Applicant: James R. Patterson  
Serial No.: 09/747,852  
Filed: December 22, 2000  
For: Magnetic Plumb Bob Holder

APPELLANT'S SUPPLEMENTAL BRIEF (37 C.F.R. 1.192)

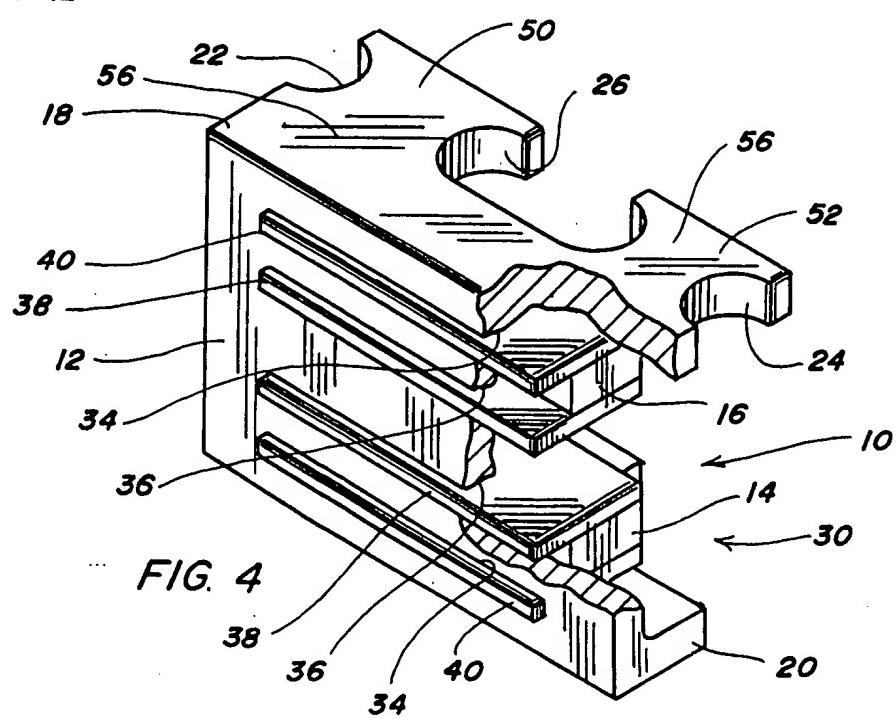
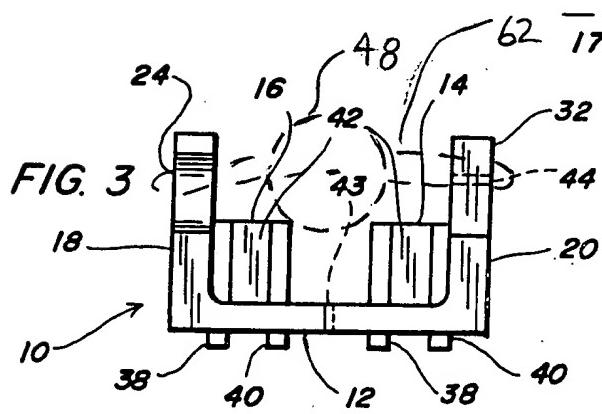
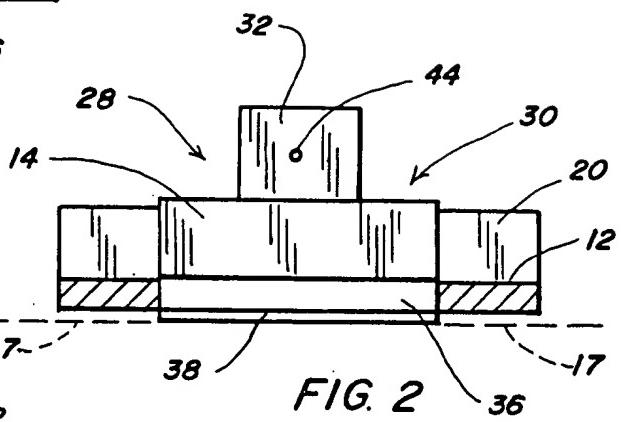
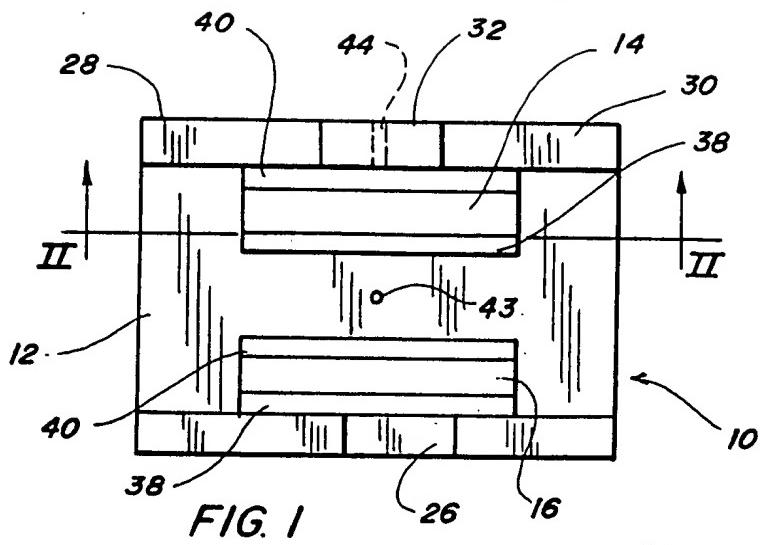
D. On January 21, 2003 Applicant appealed from the Final Rejection of October 18, 2002. Appellant's Brief on Appeal was filed May 19, 2003. On July 22, 2003 the Final Rejection of October 18, 2002 was withdrawn, prosecution of the application was reopened, and an Official Action was issued under Ex parte Quayle, 1935 C.D. 11, 453 O.G. 213. The Quayle Action of July 22, 2003 objected to the drawings and requested that the drawings be amended to show the storage feature

claimed in original claims 13 and 15. The Quayle Action further objected to the specification as failing to provide proper antecedent basis for the claimed subject matter, stating: Correction of the following is required: The specification does not clearly state what structural features of the invention provide the means for assessing the true status of a frame in relation to three dimensional space as stated in claims 1, 6 & 15. The Quayle Action also requested that "magnet" be changed to "magnetic", in claim 6, line 2, and that "status" should be added after "true" in claim 6, line 9. A further change of an "a" to a "the" was requested for claim 11, line 1.

The attached red lined copies of appellant's proposed amendments to the drawings are believed to be desirable in consideration of this appeal.

On December 22, 2003 Applicant filed Amendment D in response to the Quayle action of July 22, 2003. Appellant's Amendment D made the requested amendments to claim 6 and canceled claim 11 to simplify the issues. Amendment D made the requested addition to Figure 3 of the Drawing and added reference numerals 48 and 62 to Figure 3, as found in Figure 5. Amendment D also added reference numeral 44 to Figure 5, as found in Figure 2 (see the attached red lined drawing copies). Additional corrections were made to the specification to place the application in condition for allowance. The specification was corrected to show the best Figure number, at two places, and a reference number was corrected, at two places.

Further, to provide the requested antecedent basis, page 3, lines 24 and 25, of the specification were amended to read as follows, "Relieved areas 22, 24, and 26 may be used for storing the string of a plumb bob, by wrapping, and a plumb bob 48 may thus be stored in the space between flanges 18 and 20." Antecedent basis for the amendment to page 3 of the specification is found in original claim 13, lines 2 - 4, "...the first and second flanges being spaced to receive a plumb bob stored therein and the recesses receiving the string of a plumb bob wound thereon." Further antecedent basis is found in claim 15, lines 9 - 10, "... the first and second flanges defining a space therebetween to receive a plumb bob therein."

FIG. 5

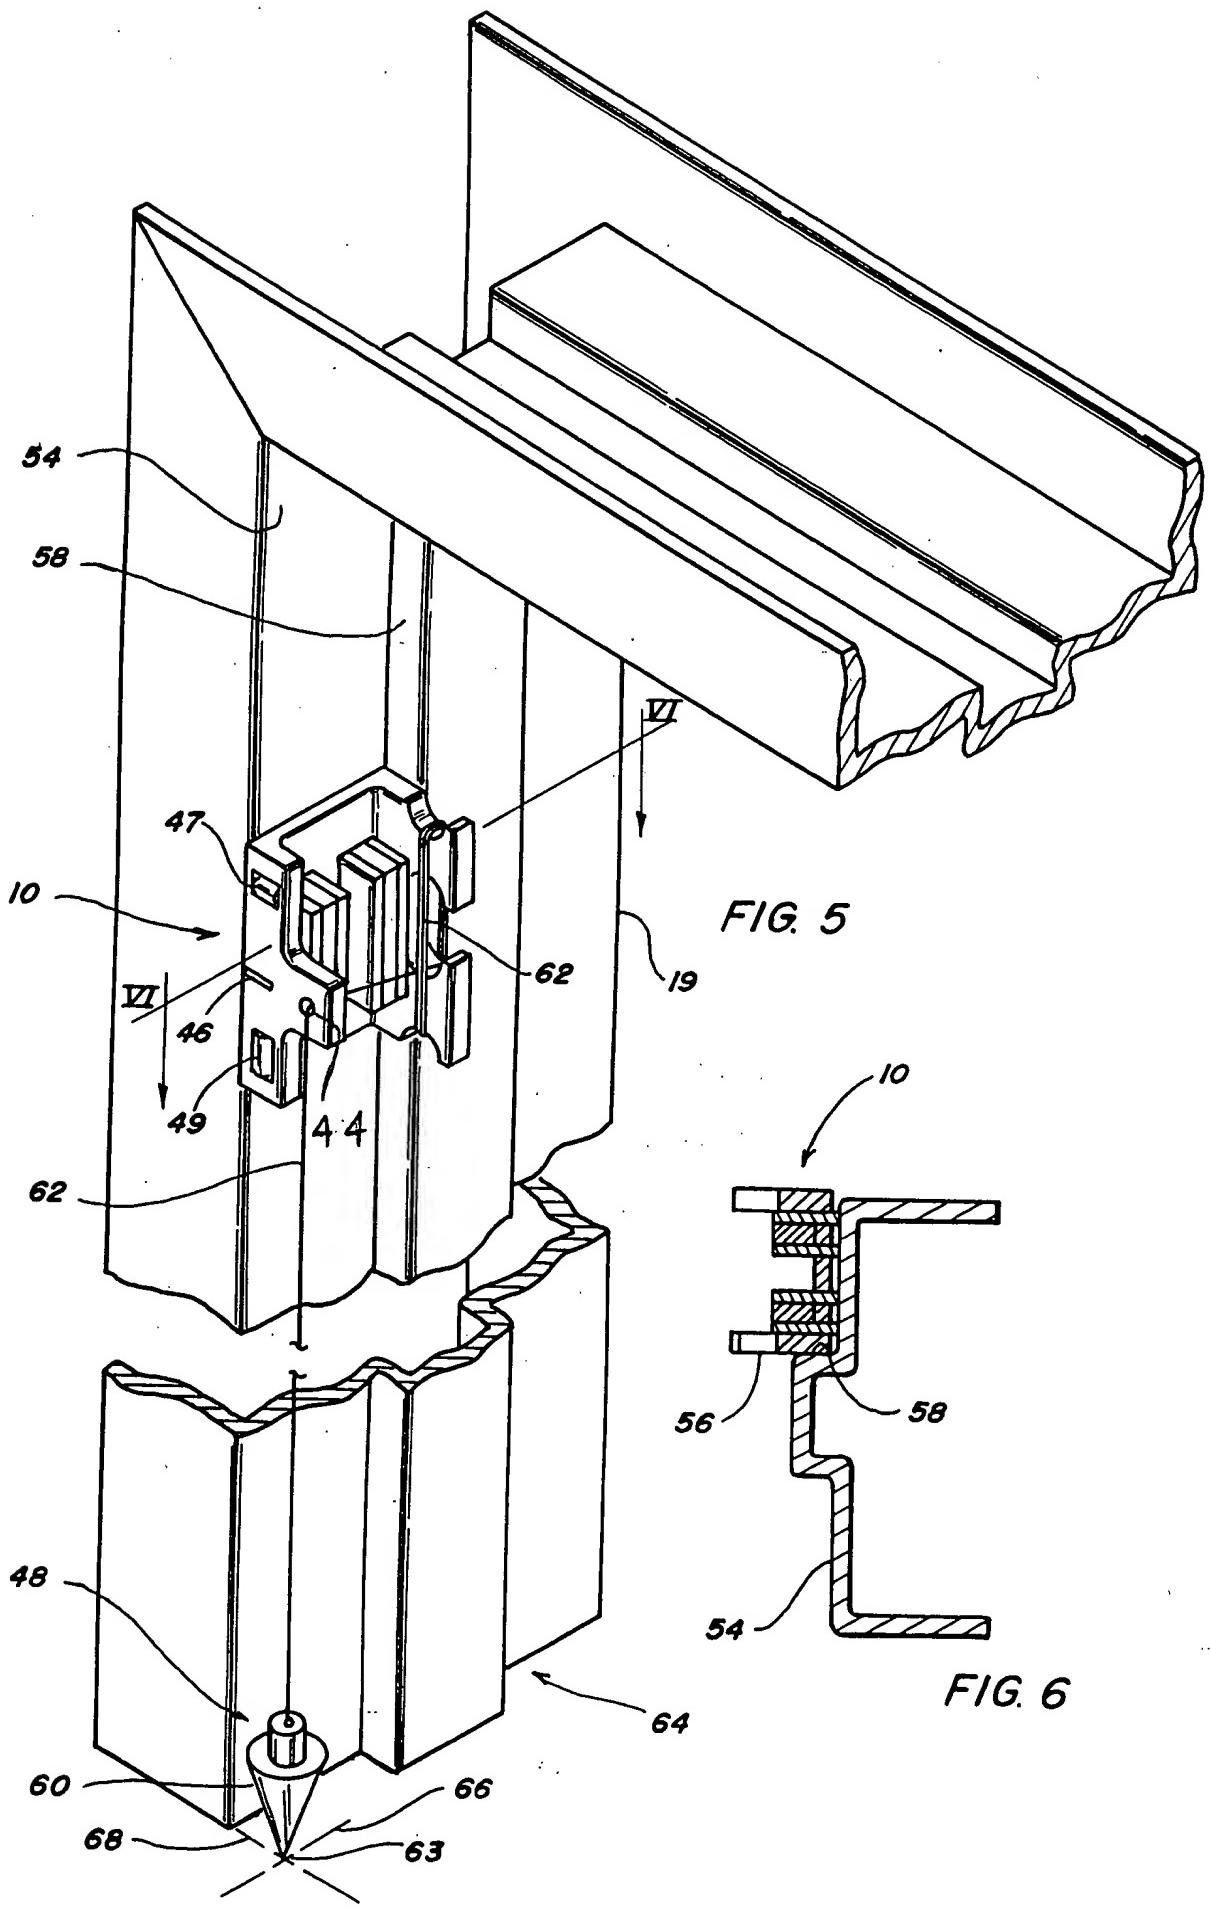
The disclosed structure allows the device to be positioned in a particular gauging relationship to a steel door frame 54, as shown in Figures 5 and 6. When so positioned, the tool may cooperate with a string 62 and a plumb bob 48 to quickly provide the information about the true status of the steel door frame 54 by modeling the dimensions of the door frame.
